RE: **PETITION NO. 1344** - The Connecticut Light and Power Company d/b/a Eversource Energy declaratory ruling, pursuant to Connecticut General Statutes §4-176 and §16-50k, for the proposed replacement of approximately 11 miles of its existing No. 1342 115-kilovolt (kV) electric transmission line structures within existing Eversource electric transmission line right of way between the existing Green Hill Substation located at 775 Green Hill Road in Madison and the existing Bokum Substation located at 49 Bokum Road in Old Saybrook, Connecticut, traversing Madison, Killingworth, Clinton, Westbrook, Essex and Old Saybrook, and related electric transmission line structure improvements.

From: Taylor, Helen M <helen.taylor@eversource.com>
Sent: Friday, March 08, 2019 11:24 AM
To: CSC-DL Siting Council
Cc: Shanley, Kathleen M; D'Angelo, Michael J
Subject: PET 1344: 1342 Line Access Road Change Request
Attachments: Lines1342_MS15_16_Rev_2019Feb.pdf

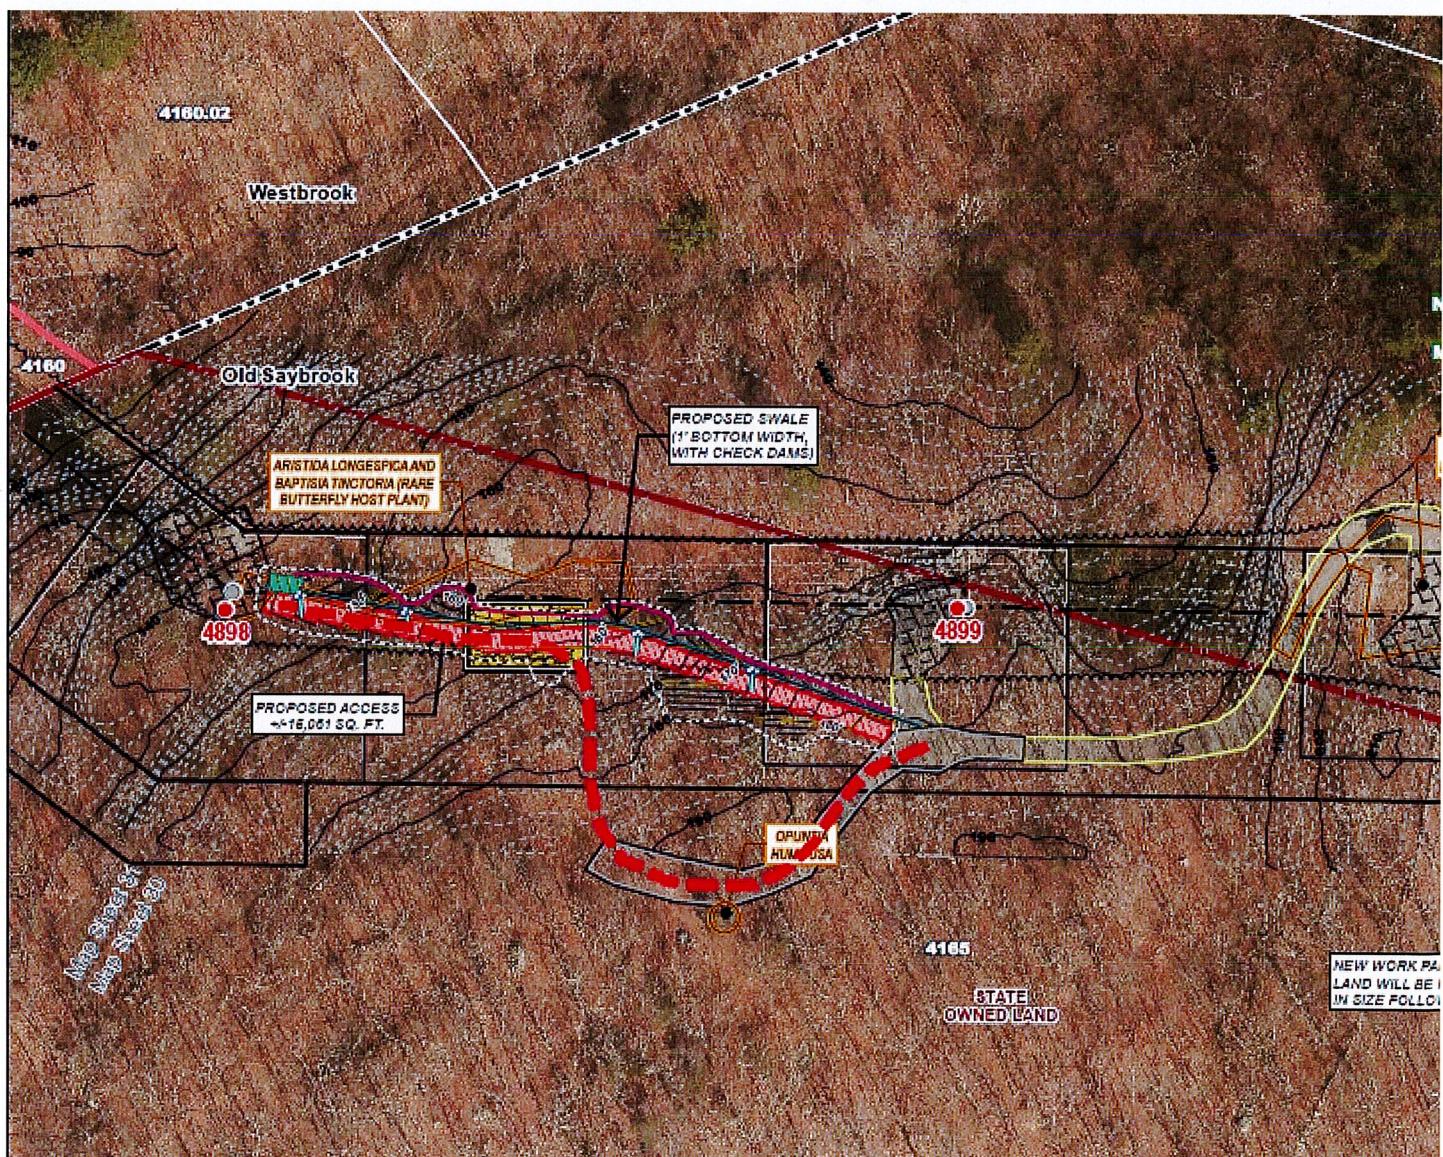
- 1) Relocate the gravel pull pad on the west side of Structure 4898 to the east side of Structure 4897.
- 2) Eliminate a second gravel pull pad on the east side of Structure 4898.
- 3) Revise access between Structures 4899 and 4898 to partially utilize an existing off right-of-way access to avoid a sensitive area within the right-of-way. Gravel associated with a portion of the access route within the right-of-way will be removed upon completion of construction.

Eversource Energy (Eversource) has been coordinating with the Connecticut Department of Energy and Environmental Protection (CTDEEP) regarding the construction near structures 4897, 4898 and 4899, "The Preserve" area, in Old Saybrook. Based on new Natural Diversity Data Base (NDDB) information, the CTDEEP has requested Eversource to relocate the pull pad at structure 4898 to structure 4897 and use an existing off right-of-way access road (see below) on state land versus building a new road within Eversource's right-of-way to minimize the impacts to environmentally sensitive areas. Eversource requesting Connecticut Siting Council staff review and approval of the proposed pad relocation and the off right-of-way access change between structures 4898 and 4899. See attached Revised Mapsheets 15 and 16.

Pursuant to Condition No. 1 of the Council's July 19, 2018 Declaratory Ruling, your request for the above minor project changes, as detailed in your March 8, 2019 correspondence, is hereby approved. This approval applies only to the minor project changes described in your March 8, 2019 correspondence. Any significant changes to the project require advance Council notification and approval.
